Recall Campaign Bulletin

Campaign No. 2019100002, October 2019

SUBJECT: Model 447 (Metris), Model Year 2016 - 2017

Steering Gear Bolt Corrosion

Shown with engine 274

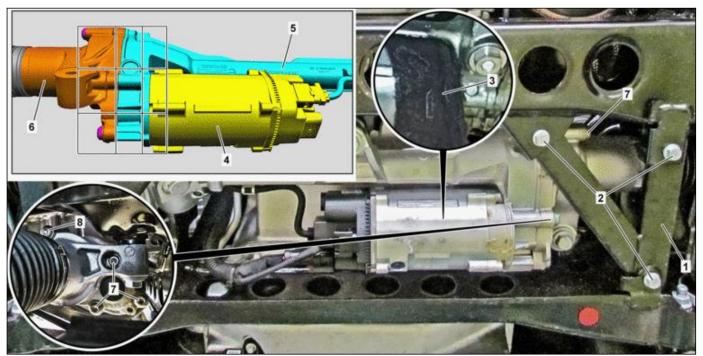
DAG determined that the aluminum bolts affixing the steering gear housing cover and the aluminum bolts affixing the power pack could corrode due to the intrusion of moisture and road salt (brine) while the vehicle is operating in certain geographic areas with high salt concentrations. Advanced corrosion can weaken the strength of the bolts. If all three of the mounting bolts on the power pack become compromised, the power pack could separate from the steering gear and cause the power steering to fail, increasing the risk of a crash. An authorized Mercedes-Benz Metris dealer will replace the aluminum bolts with steel ones and apply wax to the steering gear.

- 1. Clean steering gear
- 2. Replace screws

Clean				
5	Clean steering gear.	Do not clean steering gear using steel or brass brush. Otherwise corrosion will occur. i To do so, first remove coarse soiling in the entire repair area on the steering gear using the cleaner. Then thoroughly clean the		
		following areas (in the grid) using a fiber rag (3): - Connections, electric motor (4) to housing (5) - Connections from cover (6) to housing (5) - Areas of screws (7, 8) - Area of bores of screw (8) Assembly cleaner	BR00.45-Z-1028-04A

Wax			
7	Wax steering gear. 000 588 01 72 00 Sealing and corrosion protection gun	To do so, wax the following areas (grid) in two processes generously and thoroughly:	WS97.00-N-0002B
		 Connections, electric motor (4) to housing (5) Connections from cover (6) to housing (5) Areas of screws (7, 8)
